Access Compliance Report

Public Rights-of-Way

(Curb Ramps)

Intersection ID: 31894	Main Street: GREEN_MOUNTAIN_RD	Cross Street: MOUNTAIN_SPRINGS_DR	Location: E
ADA ID: 91A0C7D56B50	Ramp Type: PerpDiag	Initial Pass/Fail: Fail	Overall Compliance: No
Severity Score: 10			
Codes/Mitigation Info/Possible Solution		Field Measurements/Component Compliance

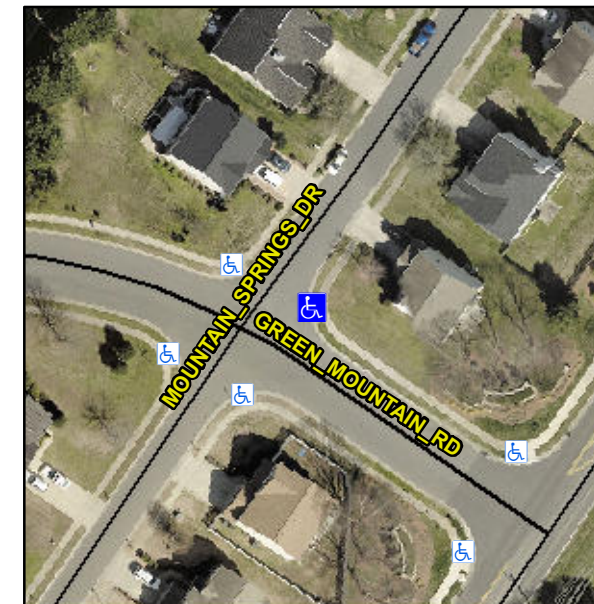
R304.5.1, R304.5.3

Compliance	Description	Data	Compliance	Description	Data
N/A	Ramp Length (in)	48.0	Yes	Ramp Slope (%)	5.3
No	Ramp Width (in)	42.0	No	Ramp XSlope (%)	4.5
N/A	Flare Type LT	N/A	N/A	Flare Type RT	N/A
N/A	Flare Slope LT (%)	N/A	N/A	Flare Slope RT (%)	N/A
N/A	Flare Traversable LT?	N/A	N/A	Flare Traversable RT?	N/A
N/A	Landing Length (in)	N/A	N/A	DWS Provided?	N/A
N/A	Landing Width (in)	N/A	N/A	DWS Contrast?	N/A
N/A	Landing Slope (%)	N/A	N/A	DWS Length (in)	N/A
N/A	Landing X Slope (%)	N/A	N/A	DWS Full Width?	N/A
N/A	Landing Curb? (Y/N)	N/A	N/A	DWS Offset (in)	N/A
N/A	Shared Landing?	N/A			
N/A	Gutter Ponding?	N/A	N/A	Gutter Slope (%)	N/A
N/A	Gutter Lip Ht (in)	N/A	N/A	Gutter X Slope (%)	N/A
N/A	Painted X Walk1?	No	N/A	Painted X Walk2?	No
	X Walk 1 Direction	To NW		X Walk 2 Direction	To SW
N/A	X Walk 1 Width (in)	N/A	N/A	X Walk 2 Width (in)	N/A
	X Walk 1 Slope (%)	4.4		X Walk 2 Slope (%)	1.3
	X Walk 1 X Slope (%)	0.3		X Walk 2 X Slope (%)	4.4

Remove & Replace Curb Ramp With Two New Directional Ramps or Equivalent.
